Canadian Standards Association  
Mississauga, Ontario  
**To the Part I Committee**

Subject No. 3092

Title: Bonding of Other Systems, Rule 10-616

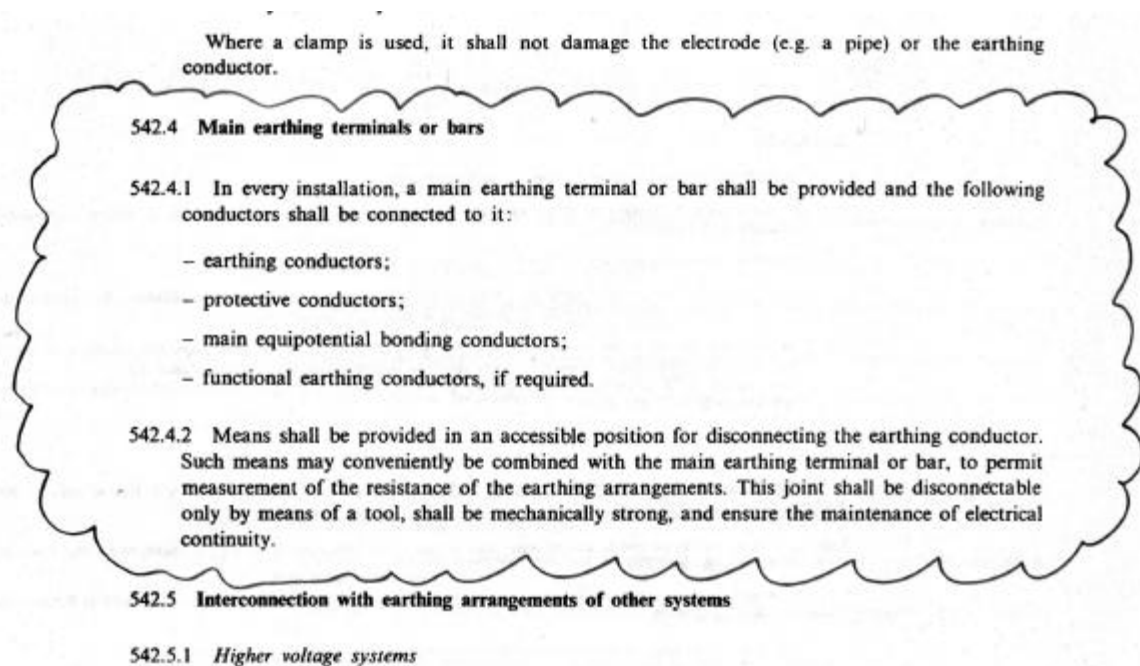
The Code requires that separate systems be bonded to reduce the differences of potential between them due to lightning or accidental contact with power lines. Lightning protection systems, communication, radio and TV, CATV and Satellite TV / Internet systems must be bonded together to minimize the potential differences between the systems. Lack of interconnection can result in a severe shock and fire hazard.

This proposal is provided to address the difficulties Communication, Community Antenna Distribution, Radio and Satellite Television Installers encounter in complying with Code grounding and bonding requirements. These difficulties arise from the increased use of plastic for water pipe, fittings, water meters, and service conduit. In the past, bonding between communication, CATV, and power systems was usually achieved by connecting the communication protector grounds or cable shield to an interior metallic water pipe, because the pipe was often used as the power-grounding electrode.

Thus, the requirement that the power, communication, CATV cable shield and metallic water piping system be bonded together was easily satisfied. If the power ground was grounded to one of the other electrodes permitted by the Code, usually by a made electrode such as a ground rod,

the bond was connected to the power grounding electrode conductor or to a metallic service raceway, since at least one of these was usually accessible. With the proliferation of plastic water pipe, the increasing tendency for service equipment (often flush mounted) to be installed in finished areas, where the grounding electrode conductor is often concealed, installers are increasingly less likely to have access to a point for connecting bonding jumpers or grounding conductors. The increased use of Roof Mounted Receiver dishes for Television, High-speed Internet and voice and data services also present the Homeowner, Business owner or their service technician with the same issues as defined in this example.
